SERVICE BULLETIN

EC14-001

2013 NV200; MIL ON WITH DTC P0456

APPLIED VEHICLE: 2013 NV200 (M20)

Figure 1

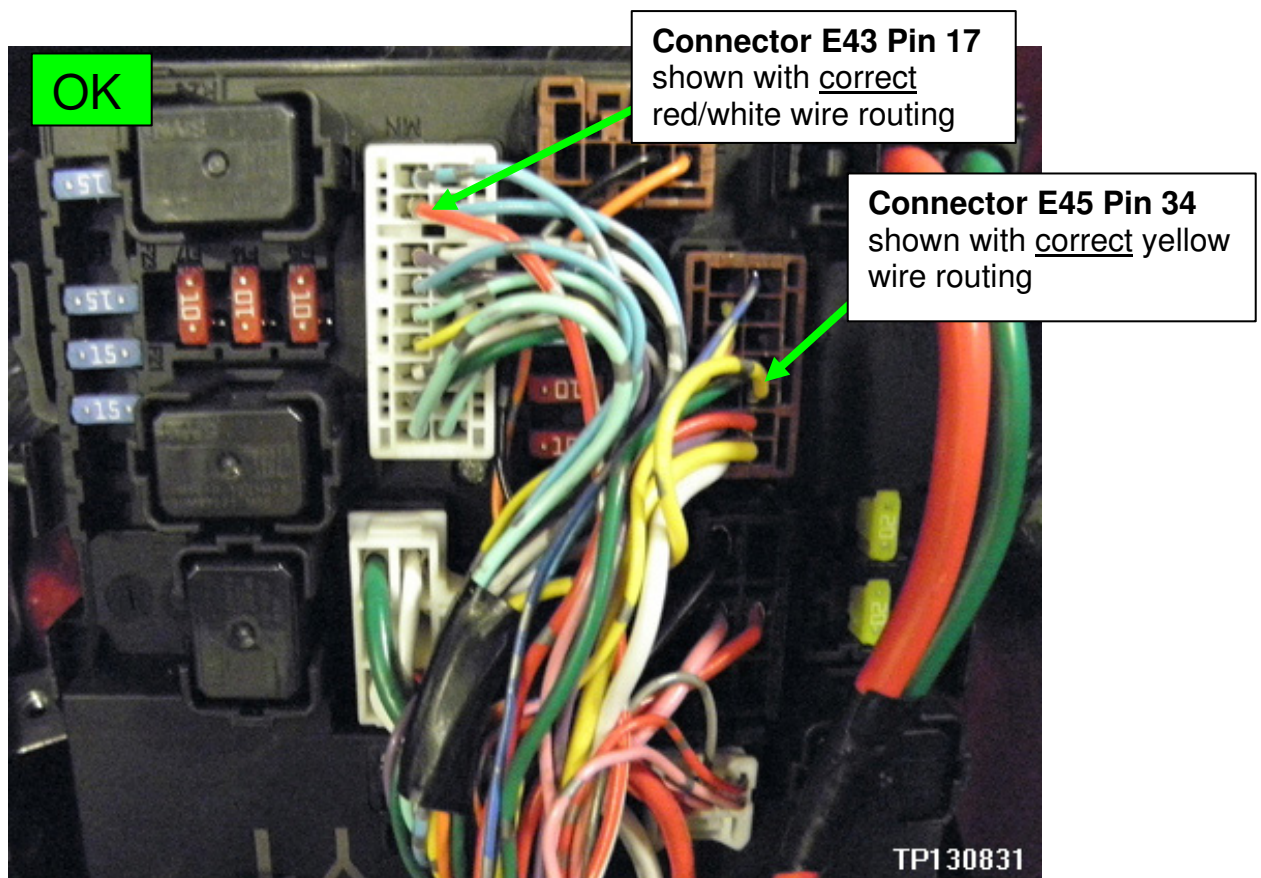
1. Turn the ignition OFF.
2. Remove the cover from the IPDM.
3. Inspect harness connectors shown in Figure 1.
 - Connector E43 pin 17, wire should be Red with White strip.
 - Connector E45 pin 34, wire should be Yellow.

NG: If harness connectors E43 pin 17 is yellow, and E45 pin 34 is red/white, proceed to **Harness Repair** on the next page.

OK: If harness colors are OK as shown above, the harness repair section of this bulletin does not apply. Refer to the Electronic Service Manual (ESM) for further diagnostics.

Figure 3

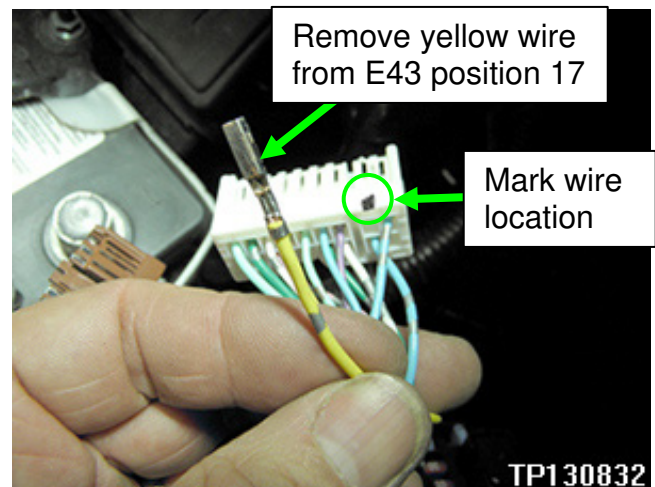
5. Mark connector E43 (Figure 3) with a felt marker next to position 17, on the “harness side”.

6. And then remove the yellow wire.

Figure 4

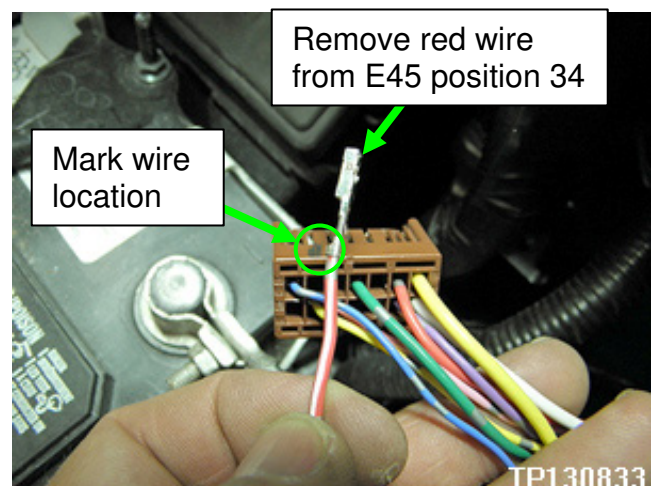
7. Mark connector E45 (Figure 4) with a felt marker next to position 34, on the “harness side”.

8. And then remove the red/white wire.

Figure 5

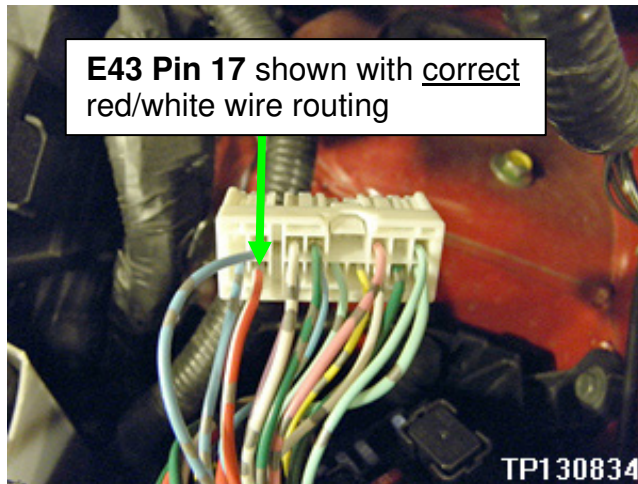
9. Install the red/white wire into the marked position on connector E43 (see Figure 5).

Figure 6

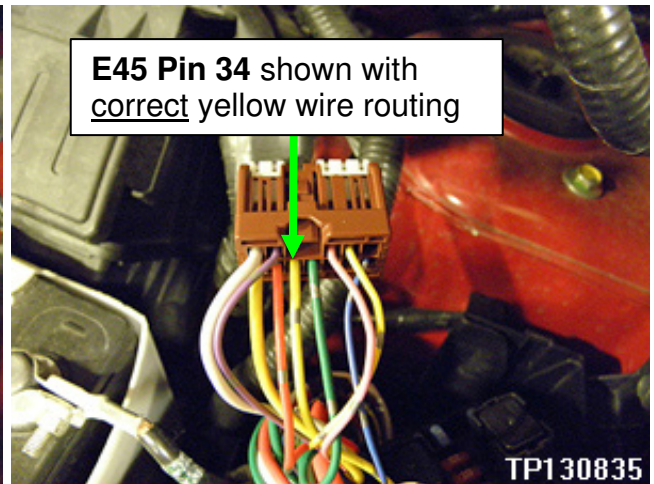
10. Install the yellow wire into the marked position on connector E45 (see Figure 6).
